**SUBJECT: COMANCHE PEAK NUCLEAR POWER PLANT, UNITS 3 AND 4
DOCKET NUMBERS 52-034 AND 52-035
SUPPLEMENTAL INFORMATION IN RESPONSE TO THE REQUEST FOR
ADDITIONAL INFORMATION REGARDING THE ENVIRONMENTAL REVIEW**

Supplemental Information in Response to the Request for Additional Information Regarding the Environmental Review

QUESTION NO.: GEN-03 (3.6.1-1) HYD-23 (9.4.2.2.5-1) and LU-03 (5.5.1.1.2-1)

Comanche Peak Nuclear Power Plant, Units 3 & 4
COL Application
Part 3 - Environmental Report

Figure 3.6-1 Sketch of Blowdown Water Treatment Facility Per Unit

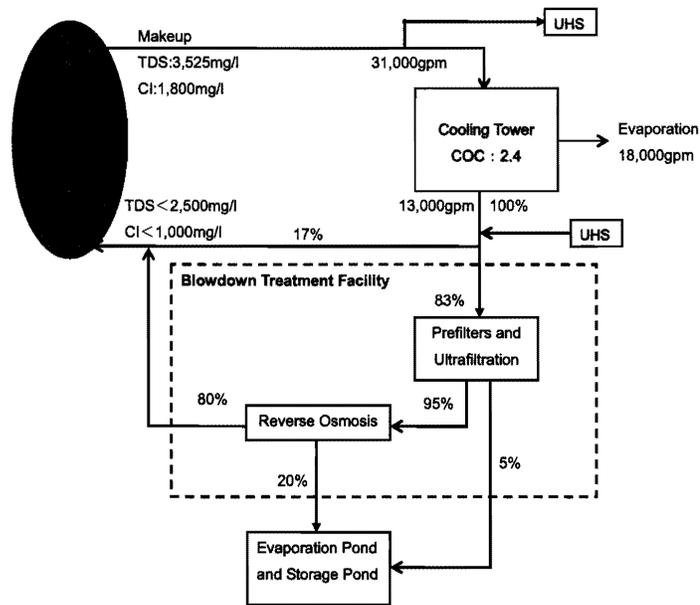
Each of the above-referenced Environmental Report (ER) RAI responses refer to some aspect of the Blowdown Treatment Facility (BDTF) and require supplemental responses. The supplemental information needed for the responses (and for the NRC to complete their review) is being provided as a combined response herein to facilitate an understanding of the system as a whole and to describe any associated potential impacts to the environment and possible mitigative measures.

For the discussions below, refer to Figure 3.6-1. The normal flow path of BDTF at the design conditions will take approximately 83 percent of the blowdown flow and divert it to the facility for treatment. Approximately 95 percent of the diverted water is filtered water and will be sent to the R/O unit. Approximately 80 percent of the filtered water will become treated water and will be reverted back to the main blowdown stream. Approximately 5 percent of the diverted water is reject water from the filters and approximately 20 percent of the filtered water is reject water from the R/O units. The reject water above will become waste water, which will be backwash containing the rejects from pre-filters, ultrafilters, and R/O membranes and will be routed either directly to the misters or the storage pond. If there are insufficient misters available (due to maintenance) to evaporate the total amount of design flow, the excess will be diverted to the storage pond and then be sent to the misters when load demand improves. New Subsection 3.6.1.4 that discusses the BDTF flow process has been added to the ER.

For the discussions below refer to Figure 3.6-1. The normal flow path of BDTF at the design conditions will take approximately 83 percent of the blowdown flow and divert it to the facility for treatment. Approximately 95 percent of the diverted water is filtered water and will be sent to the

Figure 3
Simulated Lake Granbury Elevations
Scenarios A and C - 2020 Conditions

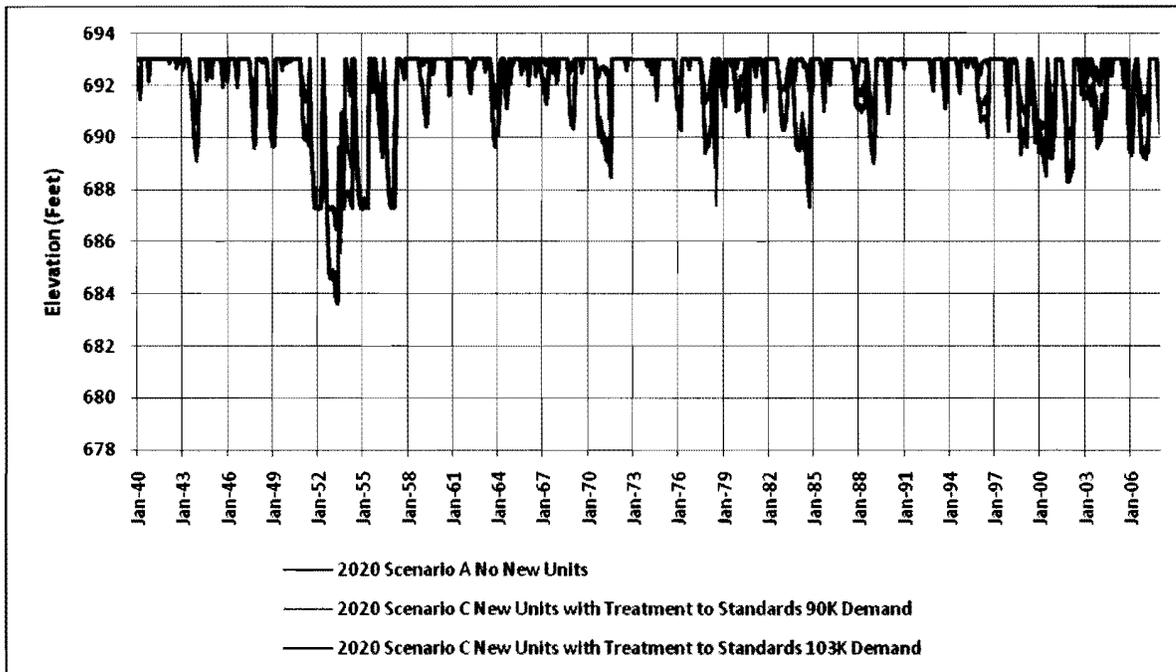
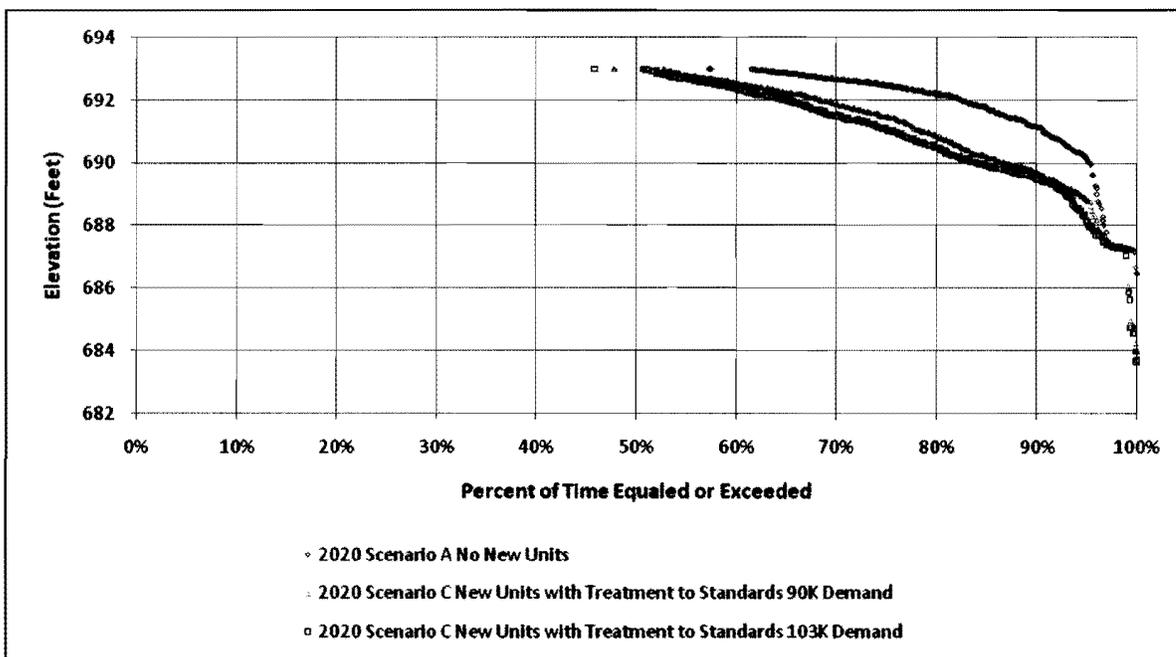
Provide estimates of the water availability, physical, and water quality impacts on Brazos River system of Brazos River system water management changes that would be induced by the implementation water rights adequate for operation of CPNPP Units 3 and 4, including water quality impacts to Possum Kingdom Lake, Lake Granbury, and the Brazos River downstream of Lake Granbury. Include quantitative multi-year time series simulation data on the elevation, inflows, releases, and water quality of reservoirs in the Brazos River system.

5. Figure 3 compares the simulated elevations in Lake Granbury for Scenarios A and C under 2020 conditions. Scenario A is shown in blue. Scenario C includes demands at both 90,152 (shown in green) and 103,717 acre-feet per year (shown in red). Figure 4 shows the exceedence frequency of the elevations in the same reservoir. Attachment 2 contains tables with the data used to create these graphs. Without the demands for the new units (Scenario A), the reservoir is full about 57 percent of the time. With the new units (Scenario C), Lake Granbury is full about 48 percent of the time at the 90,152 acre-feet per year demand level and about 46 percent of the

- time at the 103,717 acre-feet per year demand level. With the new units the reservoir is somewhat lower during dry periods. The reservoir is about 2.5 feet lower at its lowest point in March 1953 at the 90,152 acre-feet per year demand level and about 2.9 feet lower at the 103,717 acre-feet per year demand level. On average, with Units 3 and 4 (Scenario C) the reservoir is 0.4 feet lower at the 90,152 acre-feet per year demand level and 0.6 feet lower at the 103,717 acre-feet per year demand level.
